29 July 2026

Our Ref: SSD-2025/5
Our Contact: Angela Lazaridis (02) 9562 1719

Bayside Council submission on State Significant Development Application for Eastlakes Shopping Centre- 19A Evans Avenue, Eastlakes (SSD-90572458)

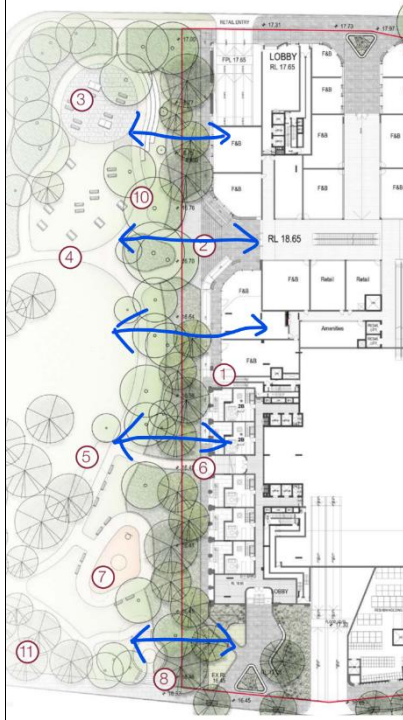
Across the precinct: of 112 total neighbouring units modelled, only 54 (48%) achieve 2+ hours — this means that 58 units (52%) do not meet the benchmark solar access required. The impacts to 22 Barber Ave are not supported: 0% solar, 0 of 4 units achieving 2+ hours of mid-winter sun. Every single unit in that building will lose solar access entirely under this modelled scenario. This represents a total loss of solar amenity. The impacts to 24 Barber Ave are not supported. only 1 of 6 units (17%) meets	Lot No.	Storeys	total units	solar %	Units >2hrs	34 Barber Ave	3	24	75%	18	32 Barber Ave	3	12	50%	6	30 Barber Ave	3	12	50%	6	28 Barber Ave	4	15	33%	5	26 Barber Ave	4	15	53%	8	24 Barber Ave	3	6	17%	1	22 Barber Ave	3	4	0%	0	20 Barber Ave	4	18	33%	6	18 Barber Ave	3	6	67%	4
Lot No.	Storeys	total units	solar %	Units >2hrs																																																	
34 Barber Ave	3	24	75%	18																																																	
32 Barber Ave	3	12	50%	6																																																	
30 Barber Ave	3	12	50%	6																																																	
28 Barber Ave	4	15	33%	5																																																	
26 Barber Ave	4	15	53%	8																																																	
24 Barber Ave	3	6	17%	1																																																	
22 Barber Ave	3	4	0%	0																																																	
20 Barber Ave	4	18	33%	6																																																	
18 Barber Ave	3	6	67%	4

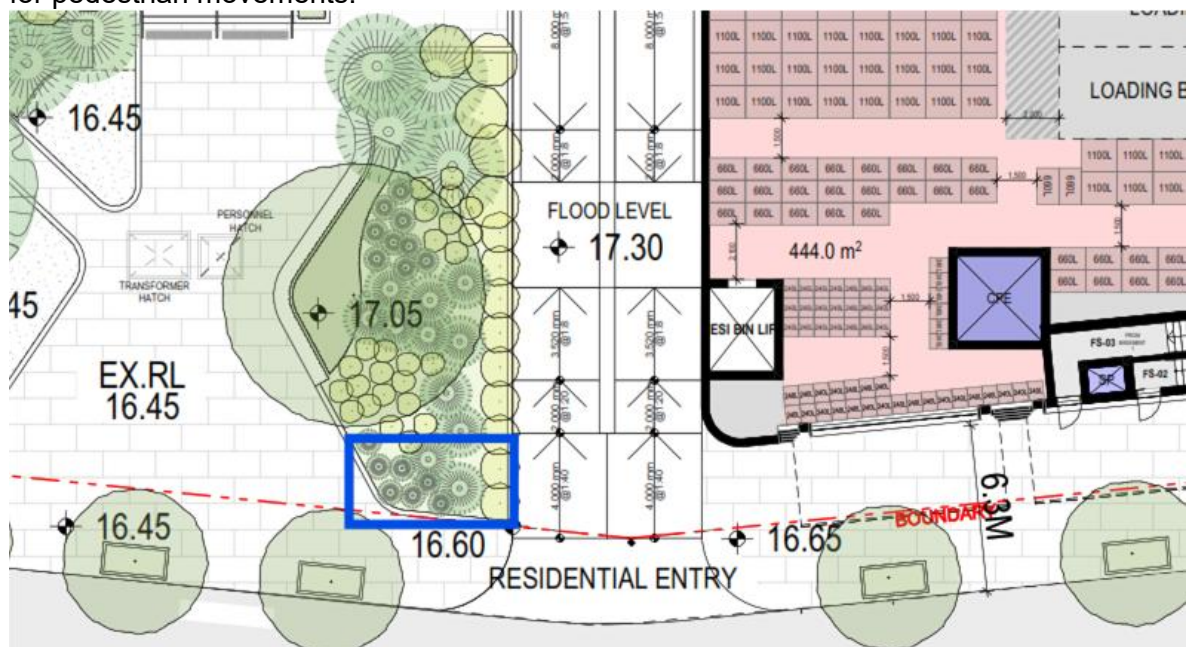
The previous approval incorporated a separated pedestrian access provision (detailed in red below on plans from previous approval) that allowed pedestrians to freely move around

the roundabout without needing to conflict with vehicles at vehicular entry. This was a separate path to the shopping centre and would've been publicly accessible at all times.

A similar outcome needs to be incorporated into this development to remove the conflict between pedestrians and vehicles at the critical northern roundabout retail entry. This path needs to operate at all times and function as a public pedestrian footpath, requiring it to be separated from the shopping centre and covered by an easement.

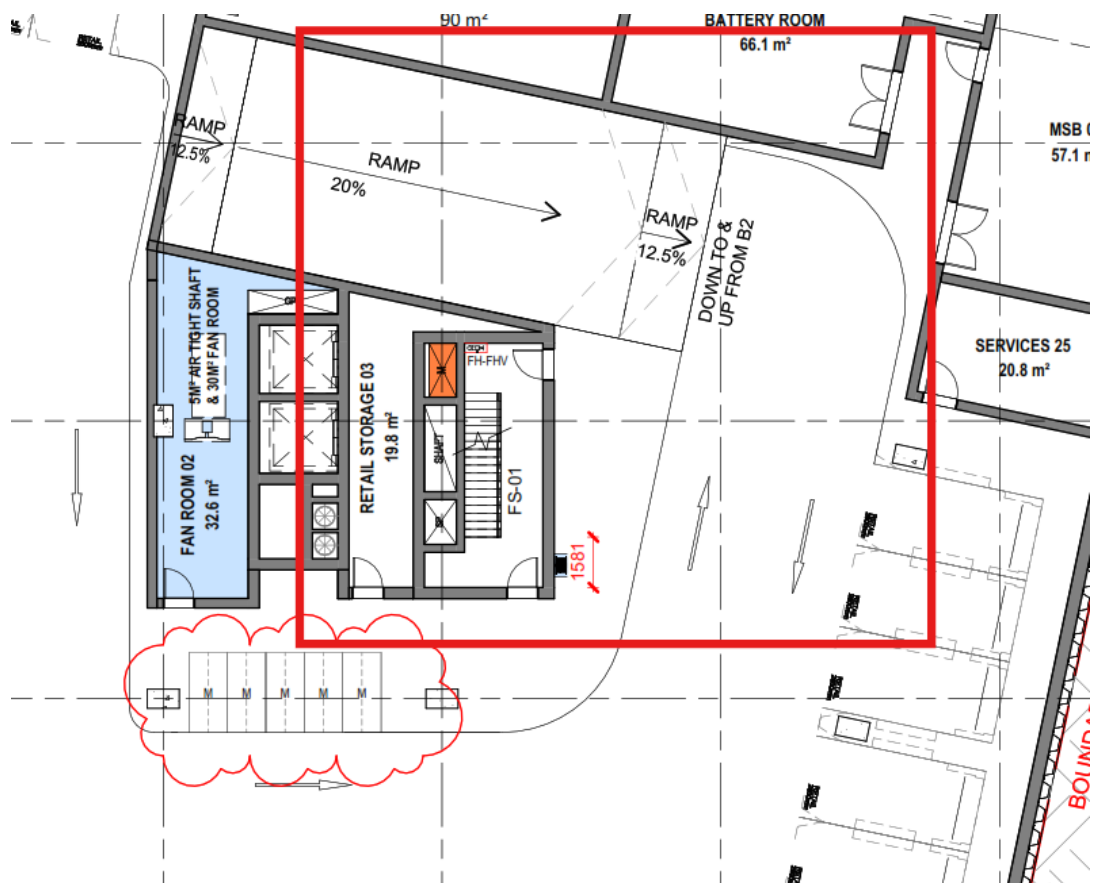
- The applicant needs to detail a way to get all trucks to undertake concrete pours, excavation activities, construction staging, and the like along their development frontage that reduces the impact on the residential streets. The applicant has been made aware that streets such as St Helena Parade and Longworth Avenue are not suitable for truck movements due to width and LATM devices, and truck movements need to occur through their site from the roundabout on Evans Avenue to Barber Avenue. There is potential to widen the verge along Barber Ave to a suitable width to allow it to be used for construction purposes (with the footpath being closed for the duration of construction subject to BTLF and obtaining the applicable permits). The CTMP needs to map out the required width (turning path analysis or similar) and determine whether the roadway could work two-way (with or without parking) or one-way with parking (residential side) in a one-way paired arrangement potentially.

Noting any proposed changes to the current road environment would require tabling at the BLTF for approval, including any changes in traffic flow. Detailed plans and a traffic study shall be provided for Councils review.

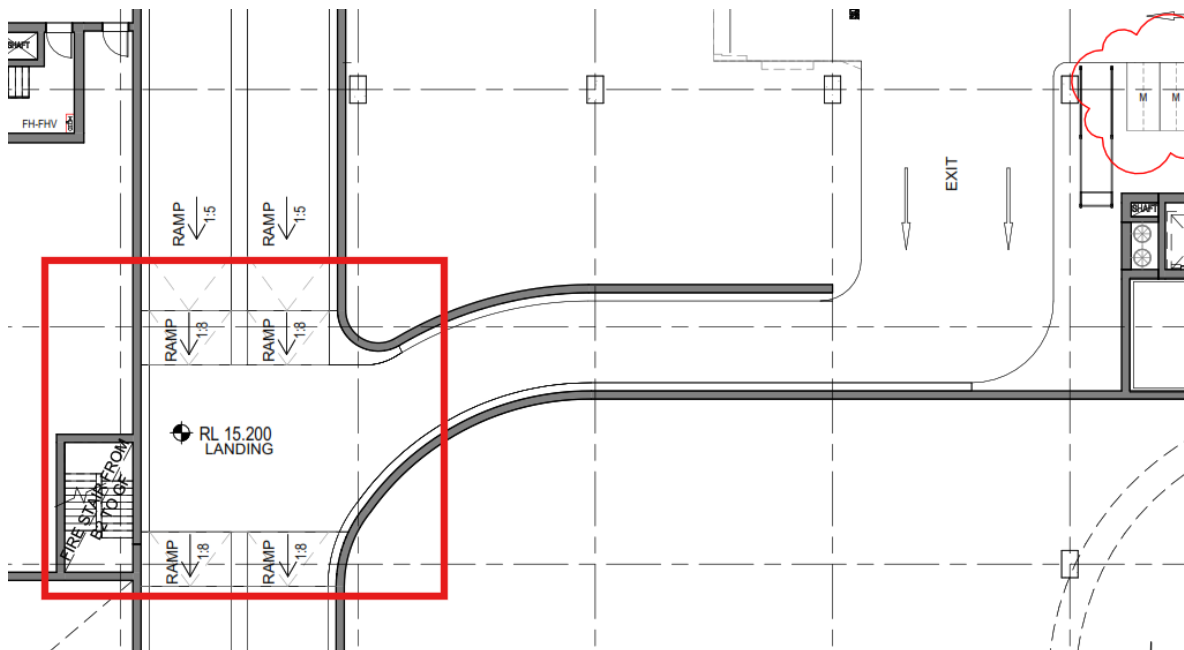
- The retail parking shall be provided with pedestrian line marking, signage, and priority control to manage traffic movements which shall be detailed on the plans. All signage and line marking shall comply with AS1742.
- A more thorough set of swept path analysis shall be provided for internal car movements with focus on critical passing areas where a B99 shall be able to pass a B99. Concerns are raised regarding the geometry of these tight turns at the top and bottom of the ramp connecting B1 to B2. These areas shall be revised to improve sight distance and minimise vehicle conflict.

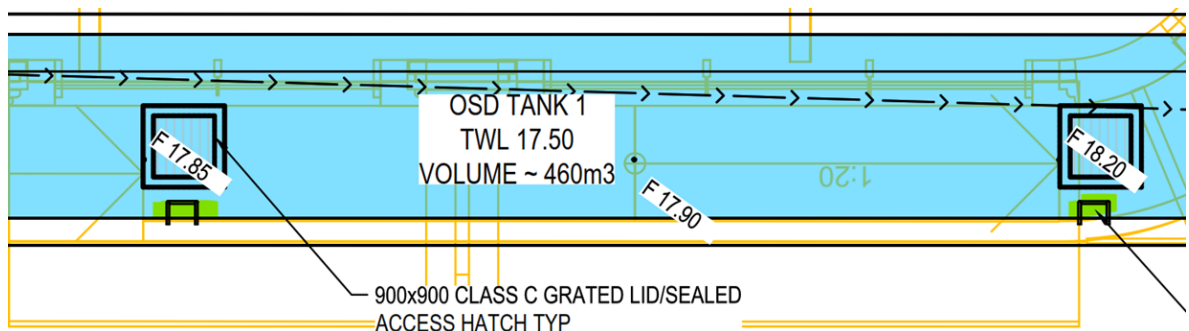
- The stormwater basement plan must show the basement as a fully “tanked” system (full structural tanking and waterproofing) with adequate provision for future fluctuation of the water table. If subsoil drainage is provided around the subsurface structure, the subsoil drainage around the subsurface structure must allow free movement of groundwater around the structure but must not be connected to the internal drainage system. No groundwater is permitted to enter the subsurface structures and, no pump-out system is permitted to be used to drain and discharge groundwater from the subsurface structures. The note on the basement drainage plan to state the above-mentioned wording regarding fully tanked system. The basement stormwater drainage plan needs to be revised to remove the subsoil lines entering the basement, no subsoil

drainage is permitted to drain into any of the basement surface inlet pits & pump tank as the basement needs to be fully tanked.

Table 14: Street Setbacks

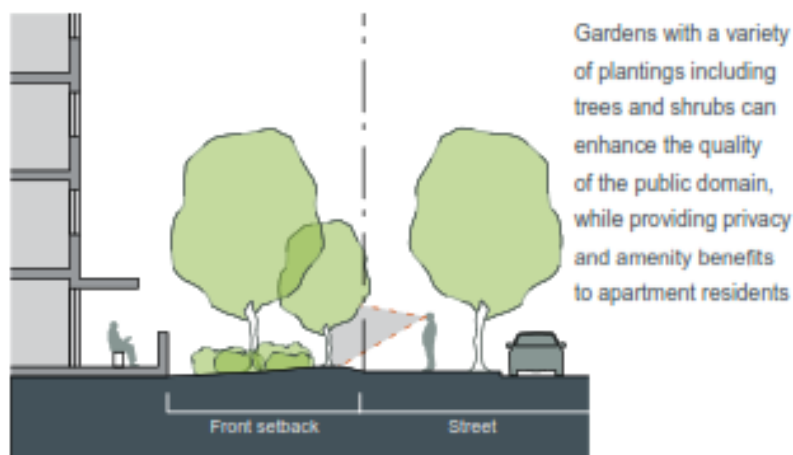
Note: Landscaping setbacks are to be free from overhangs, hard elements such as paths, ramps, substations, fire hydrant boosters, signs, parking (both above ground and underground) advertising structure (including pole signs). This quantity of landscaping may be used in calculating 10% landscaped area on site with an area below 2,000m².

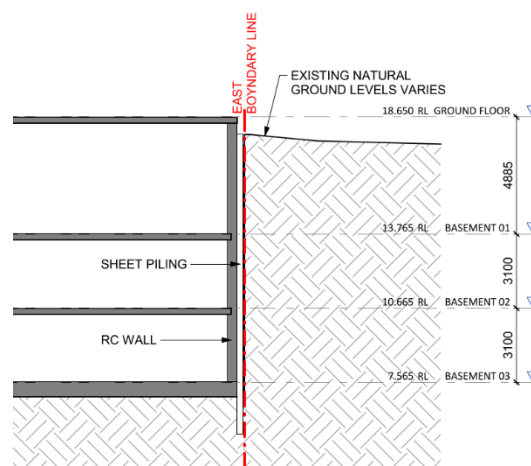
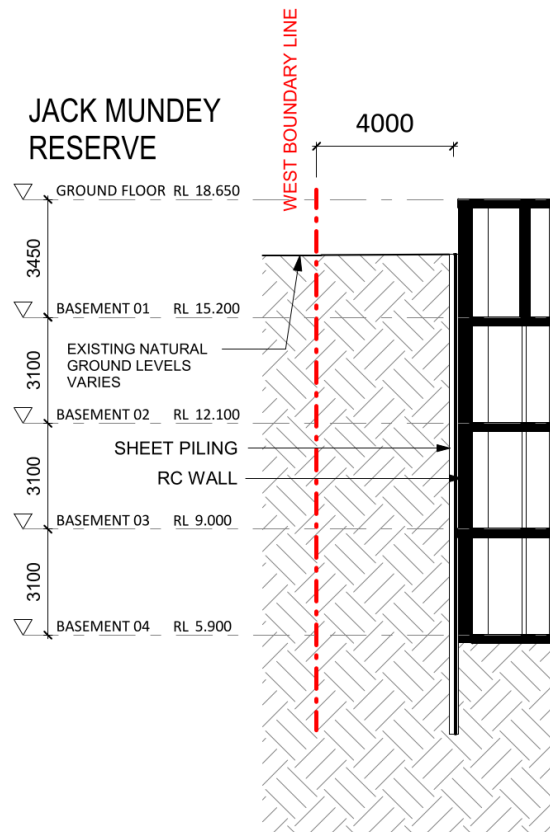
This section below demonstrates a poor relation between public domain and the shops at ground floor given the substantial level difference between ground floor and footpath level/park level.

Design changes need to be implemented to increase deep soil landscaping and provide suitable setback to the street.
